**WILSONVILLE CITY HALL
DEVELOPMENT REVIEW BOARD PANEL B**

A. Resolution No. 322.

Universal Health Services: Universal Health Services, Inc., Willamette Valley Behavioral Health- Applicant. The applicant is requesting approval of an Annexation of territory, a Comprehensive Plan Map Amendment from Washington County - Future Development - 20 District (FD-20) designation to City - Industrial designation, a Zone Map Amendment from Washington County - Future Development - 20 District (FD-20) to City - Planned Development Industrial - Regional Significant Industrial Area (PDI-RSIA) zone, a Stage I Preliminary Development Plan, Waivers, Stage II Final Plan, Site Design Review, Type C Tree Plan and Signs for an 8.72 acre site. The subject site is located on Tax Lots 400, 500 and 501 of Section 2B, Township 3 South, Range 1 West, Willamette Meridian, City of Wilsonville, Washington County, Oregon.

Documents: [UHS Staff Report.Exhibits.pdf](#), [Exhibit B1.pdf](#)

L-101

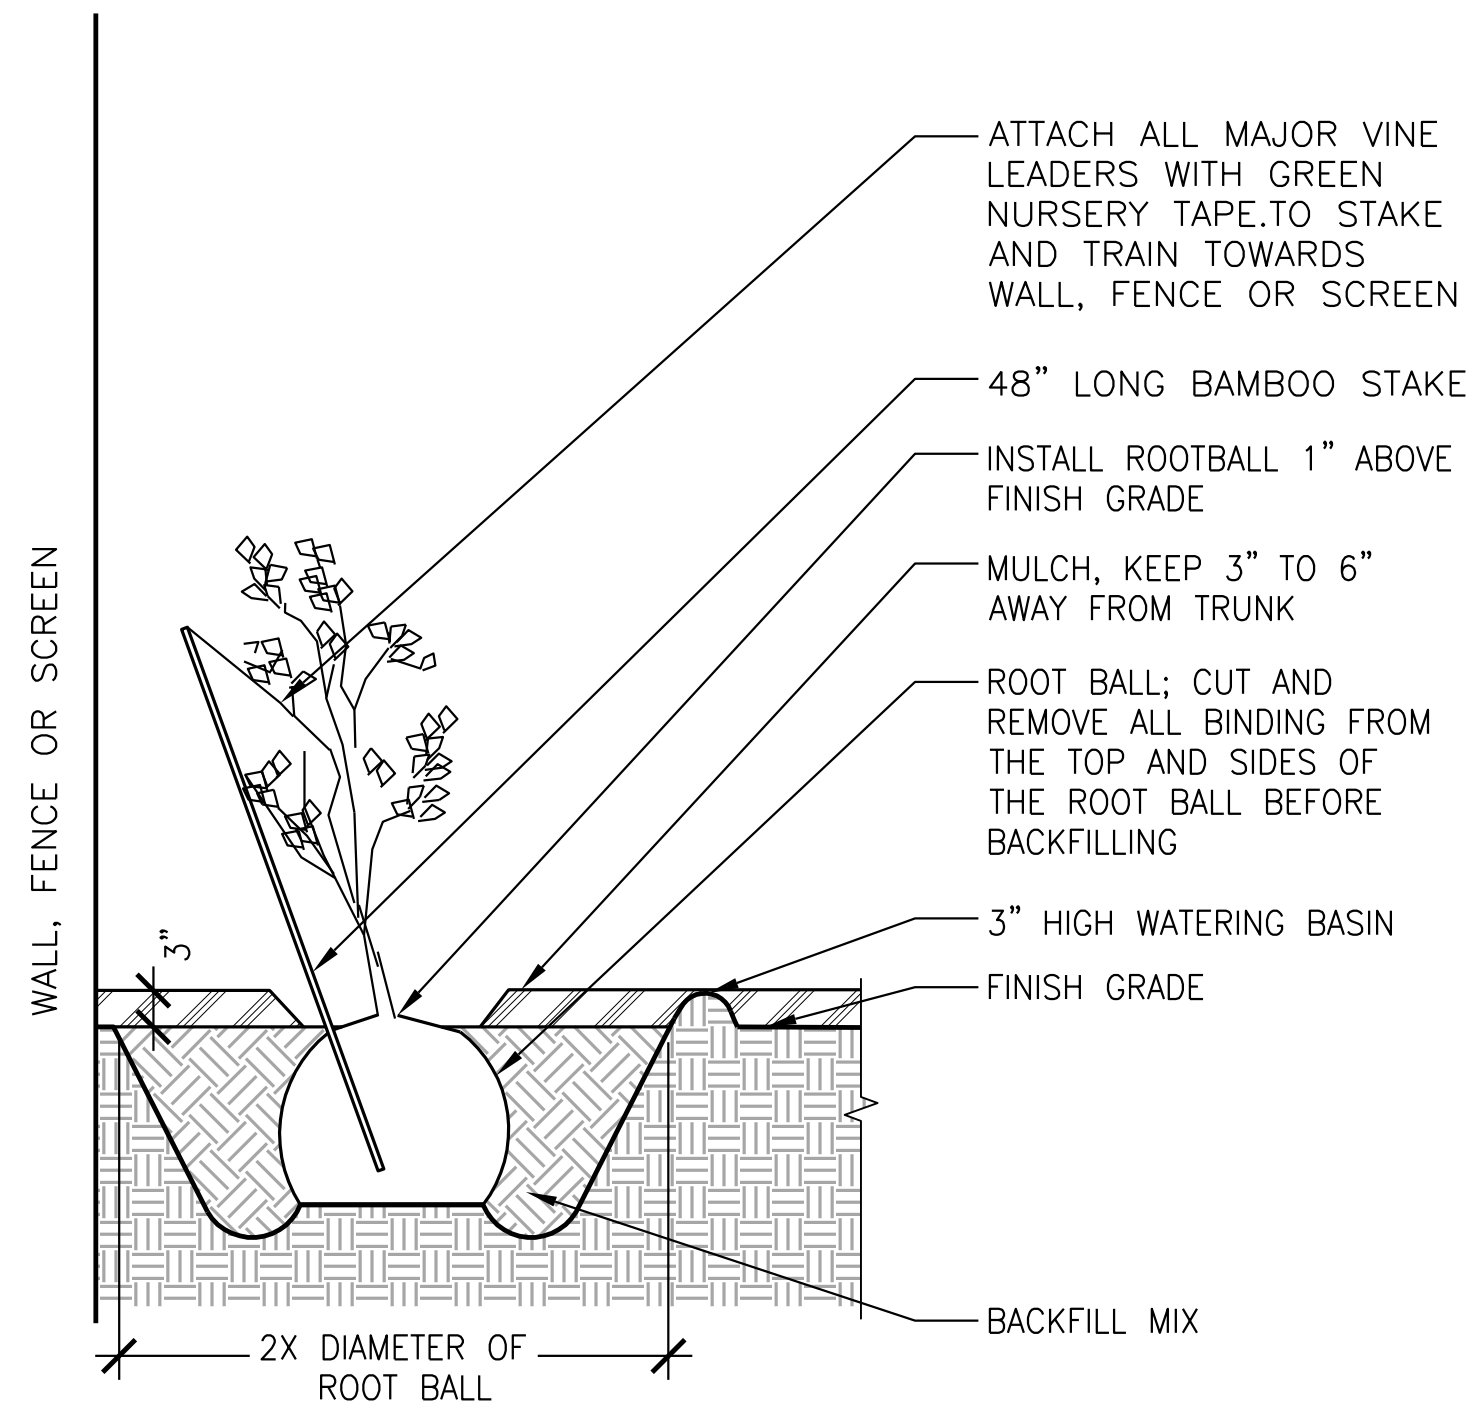
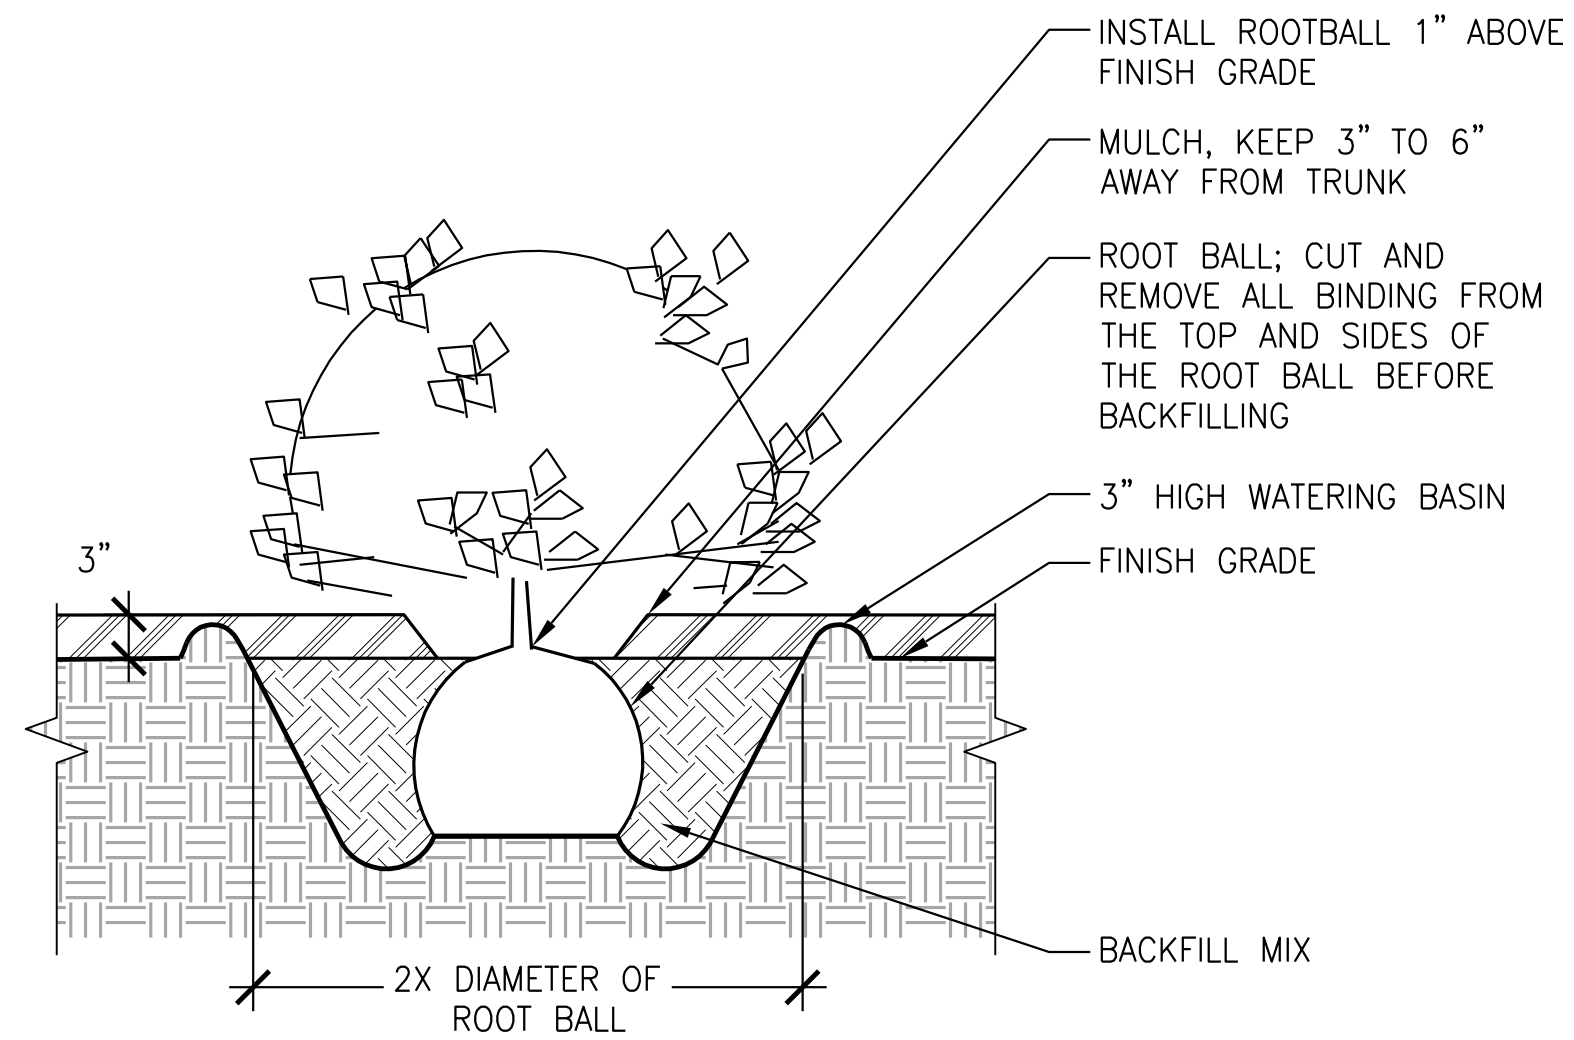
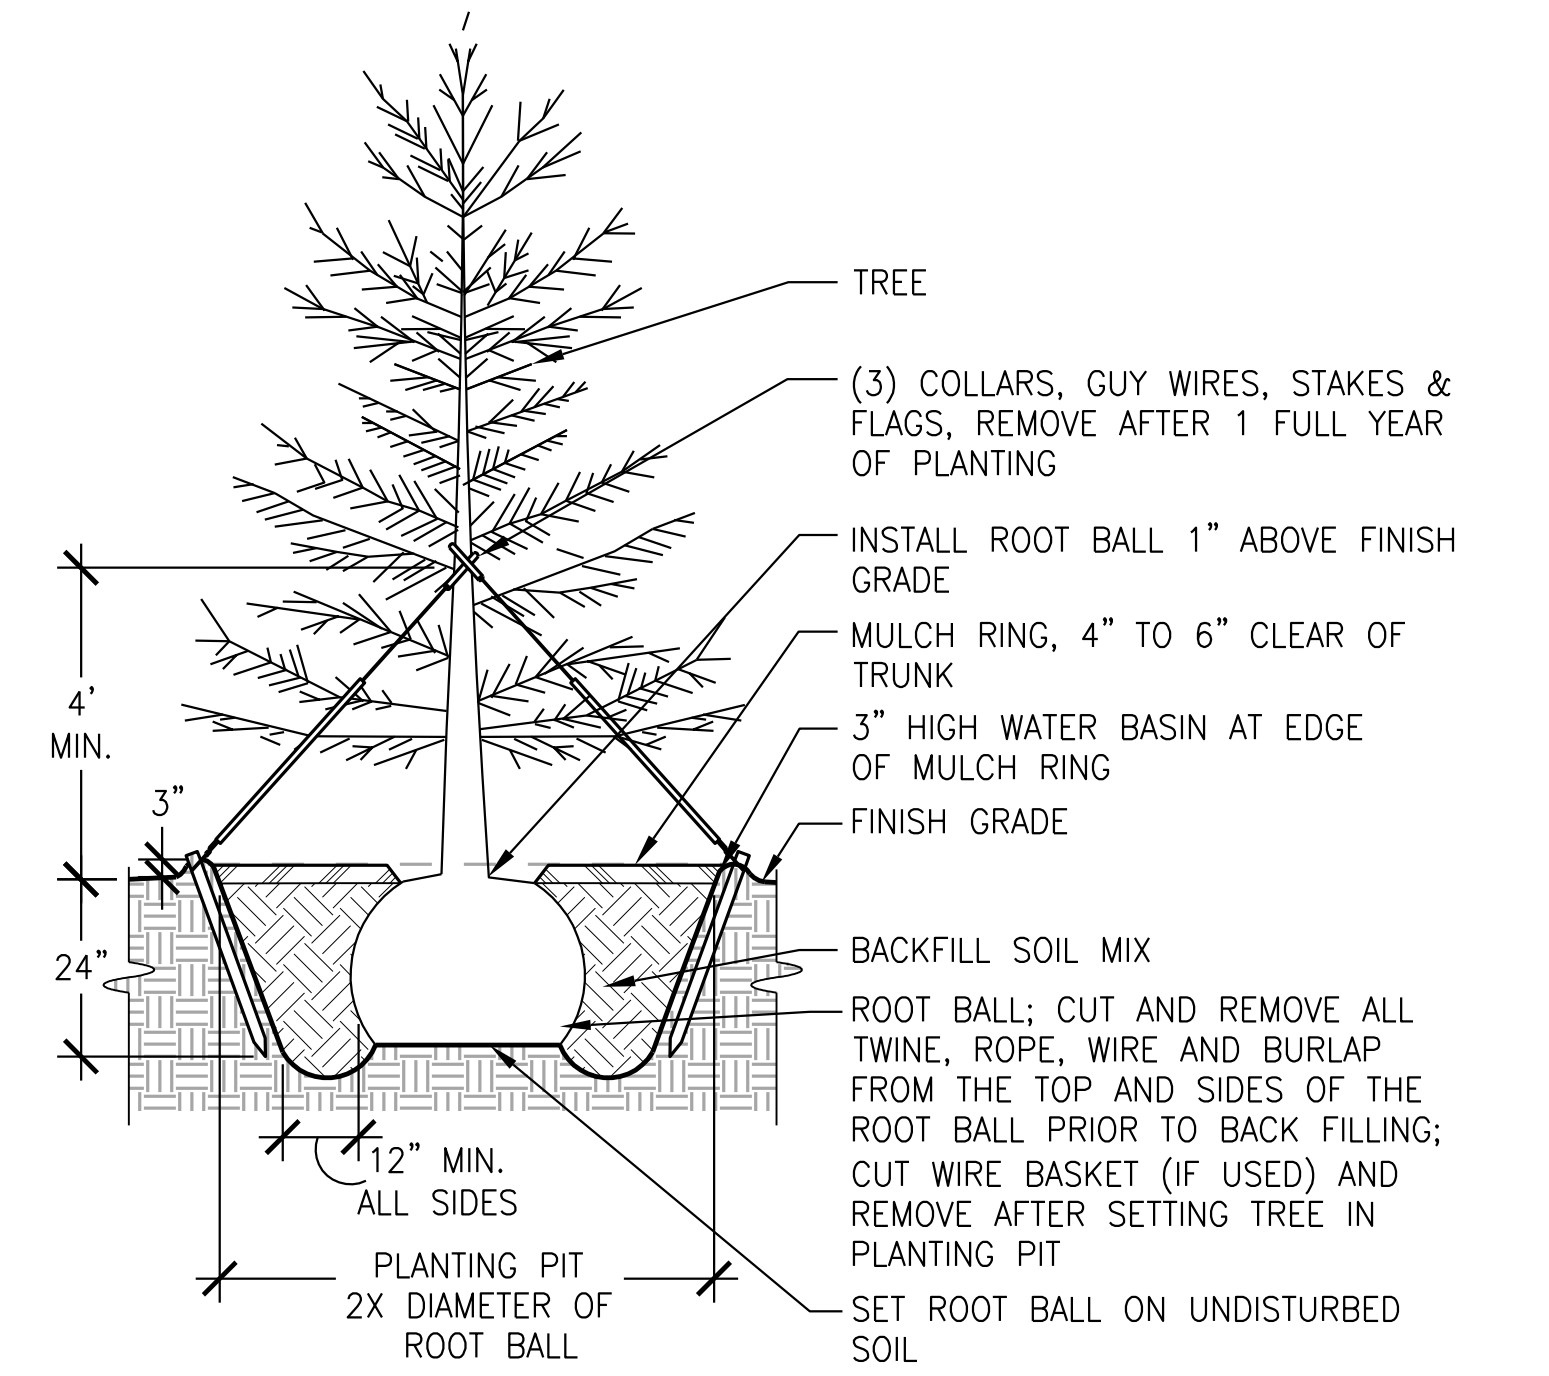
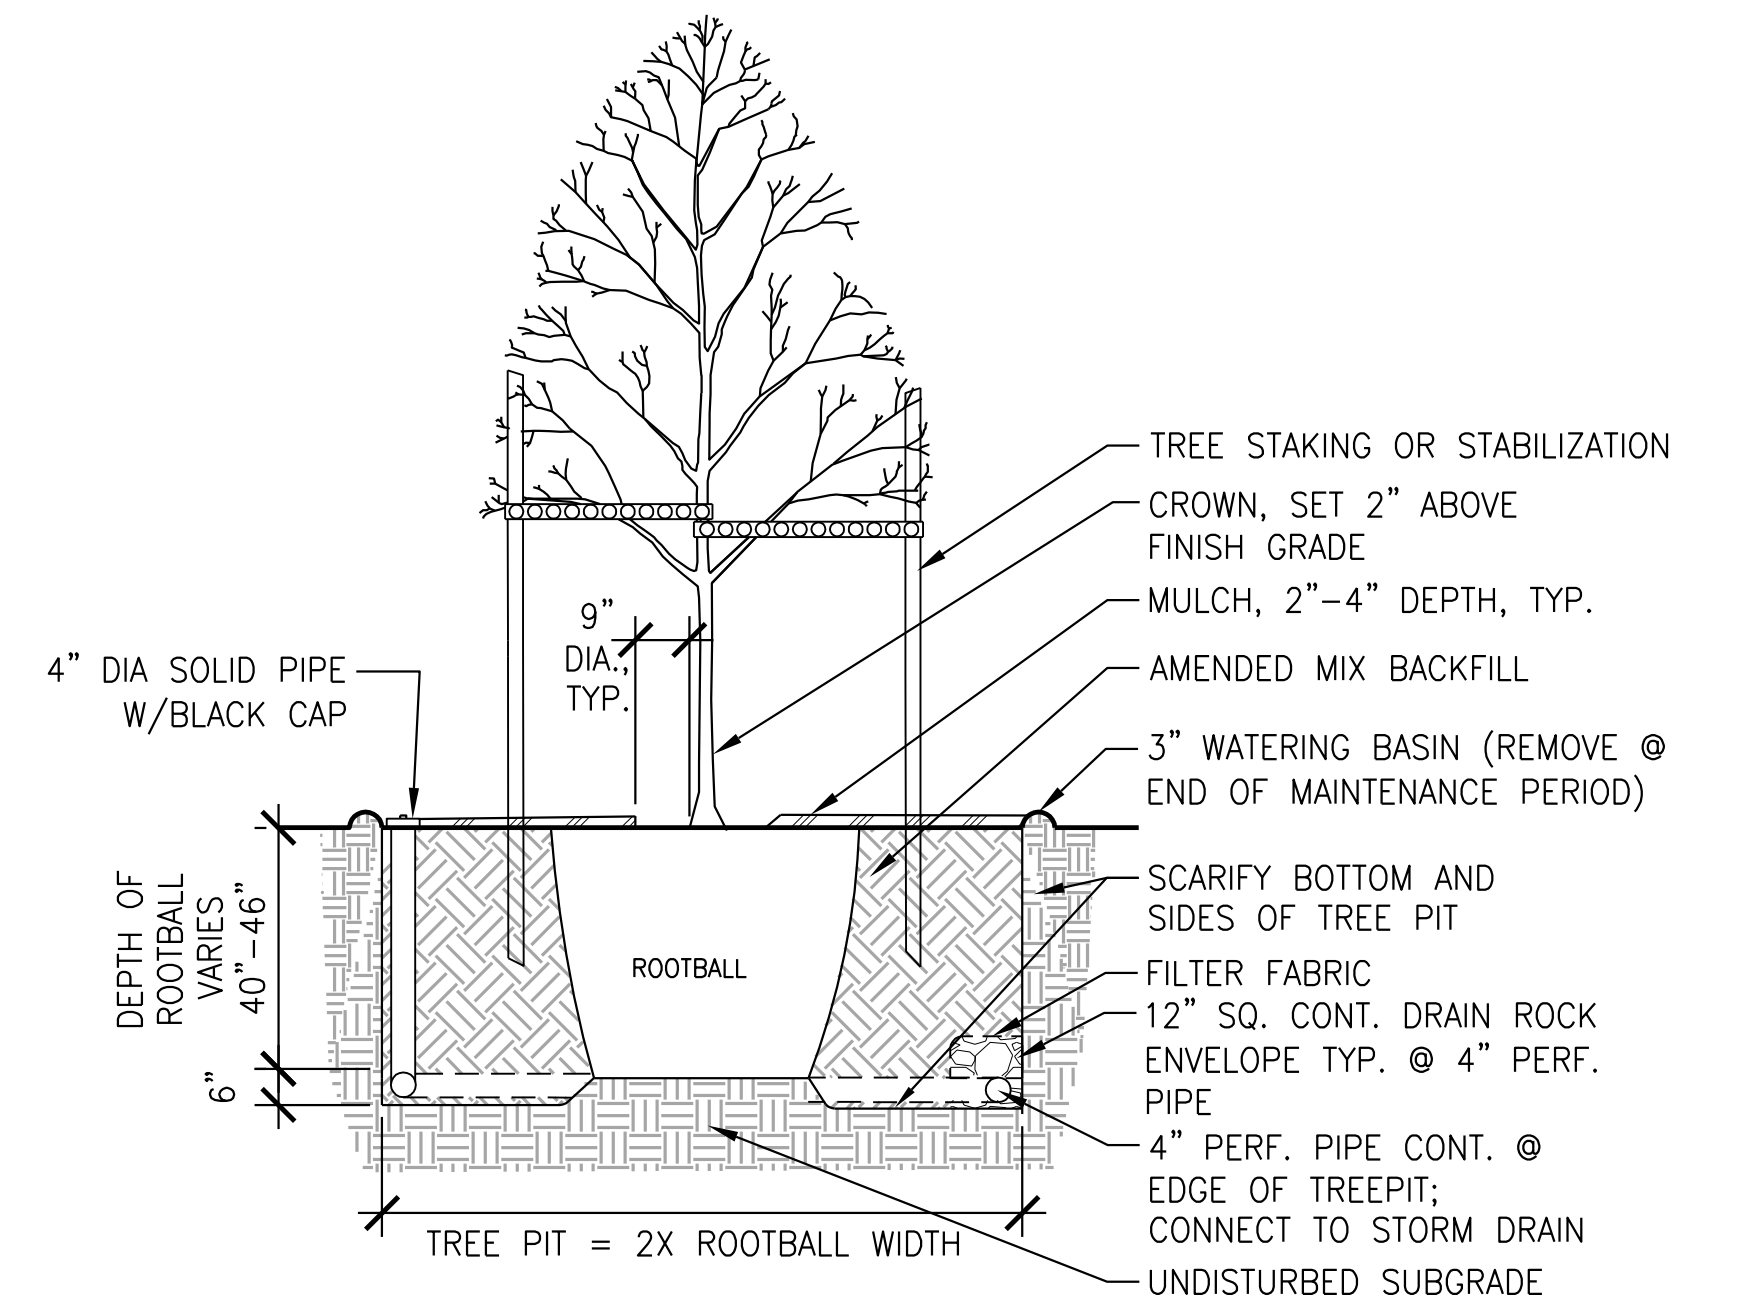
Details of Finding: Consistent with the proposed Stage II Final Plan for the site, applicant’s Plan Sheets L-100 and L-101 in Exhibit J of Exhibit B1 indicates new landscaping will cover 39% and undisturbed native area at 17% of the site. Landscaping is proposed in a variety of different areas. Planting areas are provided around the proposed building. A wide variety of plants have been proposed to achieve a professional design. The design includes consideration of using native plants and trees, including use of Western sword fern, Vine Maple, Western red cedar and Douglas-fir.

- The applicant’s planting plan (Plan Sheets L-101 of Exhibit B1) shows all trees as B&B (Balled and Burlapped)
- Plant materials installed will conform in size and grade to “American Standard for Nursery Stock” current edition.”
- The applicant’s planting plan lists tree sizes meeting requirements.

Details of Finding: The applicant has provided sufficient information in their landscape plan (Plan Sheets L-100 and L-101) showing the proposed landscape design meets the standards of this subsection.
